Access Compliance Report

Public Rights-of-Way

Intersection ID: 12935	Main Street: GAYNELLE_DR	Cross Street: HICKORY_GROVE_RD	Location: NW
ADA ID: 66E18D02784B	Ramp Type: PerpDiag	Initial Pass/Fail: Fail	Overall Compliance: No
		Severity Score: 10

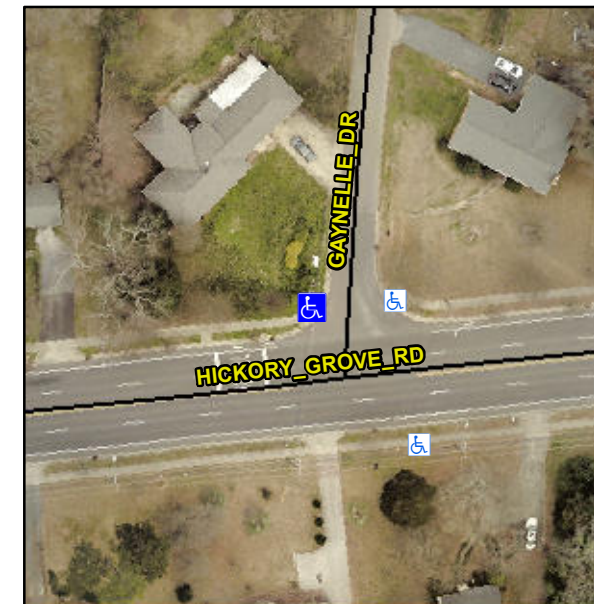
R304.5.1, R304.5.3

Compliance	Description	Data	Compliance	Description	Data
N/A	Ramp Length (in)	58.0	Yes	Ramp Slope (%)	5.0
No	Ramp Width (in)	40.0	No	Ramp XSlope (%)	3.2
N/A	Flare Type LT	N/A	N/A	Flare Type RT	N/A
N/A	Flare Slope LT (%)	N/A	N/A	Flare Slope RT (%)	N/A
N/A	Flare Traversable LT?	N/A	N/A	Flare Traversable RT?	N/A
N/A	Landing Length (in)	N/A	N/A	DWS Provided?	N/A
N/A	Landing Width (in)	N/A	N/A	DWS Contrast?	N/A
N/A	Landing Slope (%)	N/A	N/A	DWS Length (in)	N/A
N/A	Landing X Slope (%)	N/A	N/A	DWS Full Width?	N/A
N/A	Landing Curb? (Y/N)	N/A	N/A	DWS Offset (in)	N/A
N/A	Shared Landing?	N/A			
N/A	Gutter Ponding?	N/A	N/A	Gutter Slope (%)	N/A
N/A	Gutter Lip Ht (in)	N/A	N/A	Gutter X Slope (%)	N/A
N/A	Painted X Walk1?	No	N/A	Painted X Walk2?	No
	X Walk 1 Direction	To S		X Walk 2 Direction	To E
N/A	X Walk 1 Width (in)	N/A	N/A	X Walk 2 Width (in)	N/A
	X Walk 1 Slope (%)	0.8		X Walk 2 Slope (%)	2.7
	X Walk 1 X Slope (%)	4.9		X Walk 2 X Slope (%)	0.7

Remove & Replace Curb Ramp With Two New Directional Ramps or Equivalent.
